Subject: Public Comment re. Spieker Proposal

This is Public Comment on the Draft EIR for County File # CDGP20-00001, CDRZ20-03255, CDMS20-00007, CDDP20-03018, & CDLP20-02038, The Spieker Senior Continuing Care Retirement Project

Map Portfolio—Save Seven Hills Ranch

17 All Constraints (Walnut Creek: 15% slope) / Alternatives Map

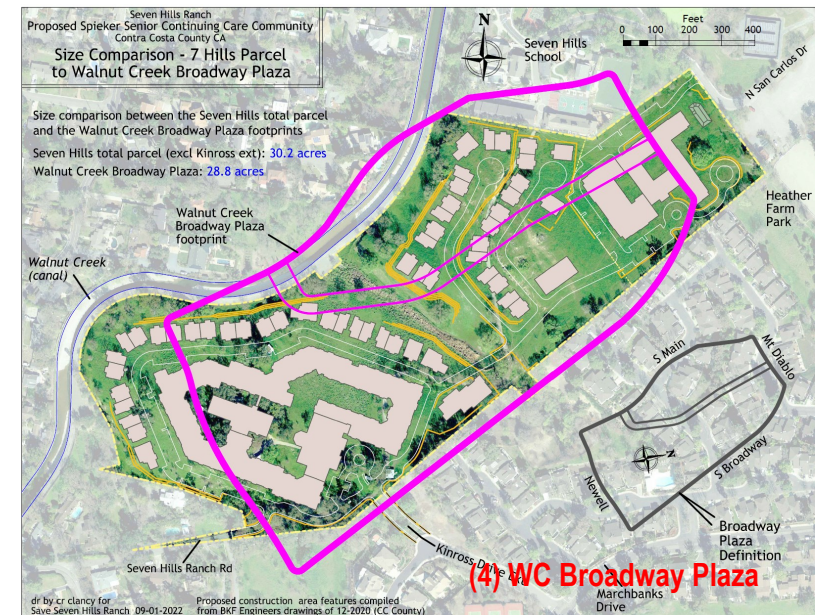
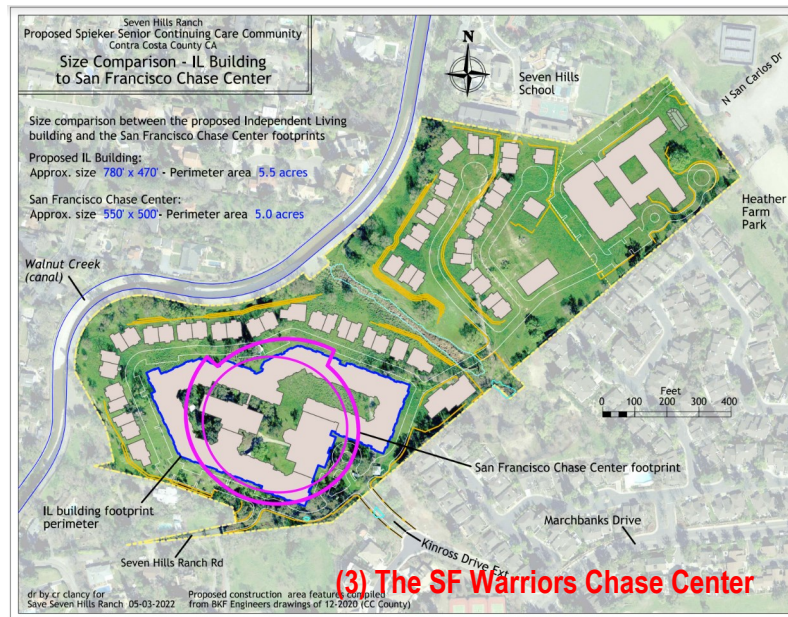
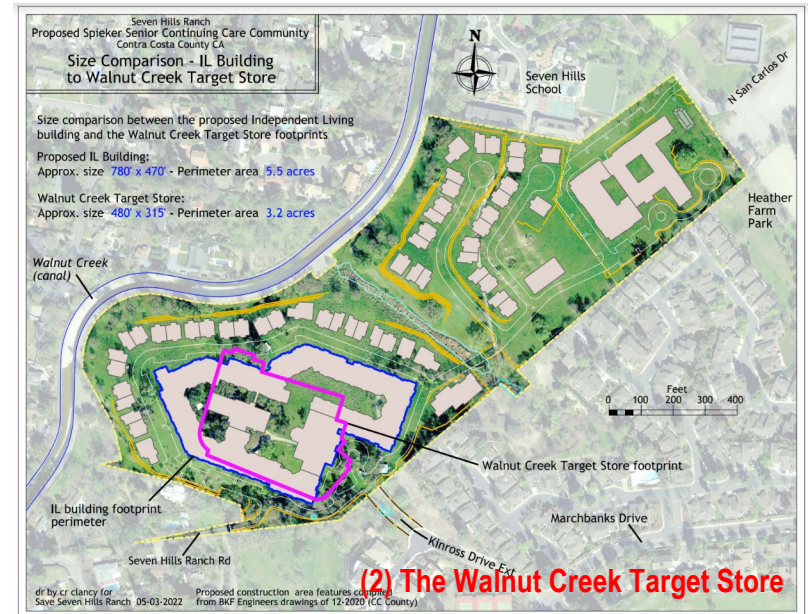
This map shows the potential development area after all foreseeable constraints have been applied: slopes greater than 15%, preserved tree buffers, wetland buffers, Valley Oak Woodlands, and a Walnut Creek channel / Pool restoration setback. Aids to visualize the possibilities for alternative development.

18 Footprint Comparison: Spieker Development Proposal IL Building with (1) the Oakland Coliseum, (2) the Walnut Creek Target Store, and (3) the SF Chase Center; (4) Entire Seven Hills development with Walnut Creek Broadway Plaza

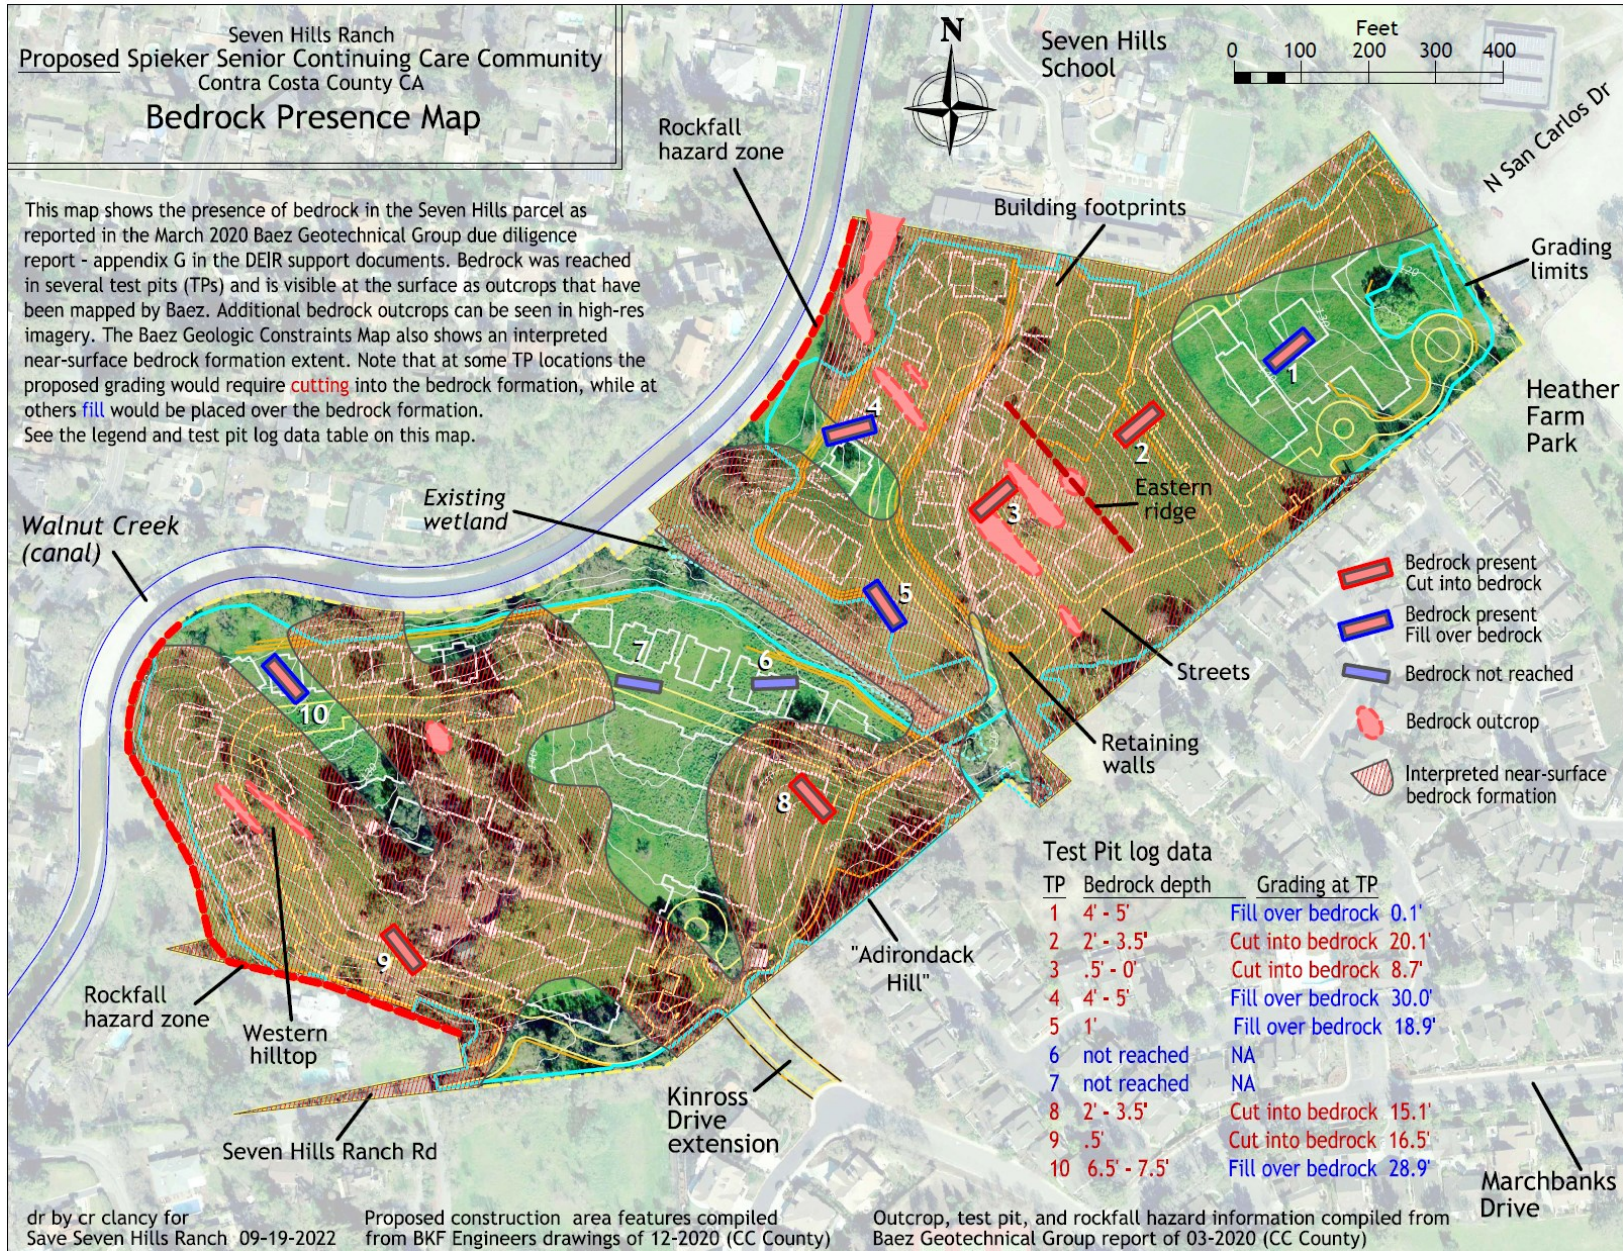
The proposed development design includes the leveling down of hills on the west side of the site and the construction of a very large pad on which the Independent Living Building and some of the 'cottages' are to be built. Here the footprints of known buildings are superimposed over the IL building to allow comparison and visualization of the large building pad and the potential environmental impact of the proposed development design.
